APPLICATION NO.	FILING DATE	FIRST NAMED INVENTOR	ATTORNEY DOCKET NO.	CONFIRMATION NO.
10/085,040	03/01/2002	Joseph C. Cauthen	08442.0002-04	8078

Office Action Summary

DETAILED ACTION

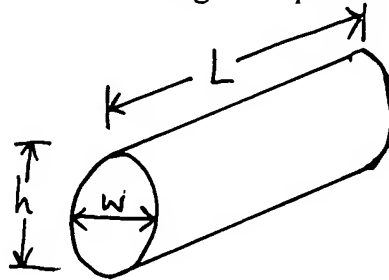
Bao et al. discloses an annulus stent for repairing an aperture in an intervertebral disc with all the elements of claim 45. See column 7, lines 62-67 for the annulus stent having a spool-like configuration. The spool shaped stent comprises the centralized vertical extension, wherein one enlarged end portion is the upper section and the other enlarged end portion is the lower section. The section between the enlarged end portions is the recess that enables the annulus stent to form a compatible fit with the edges of an aperture.
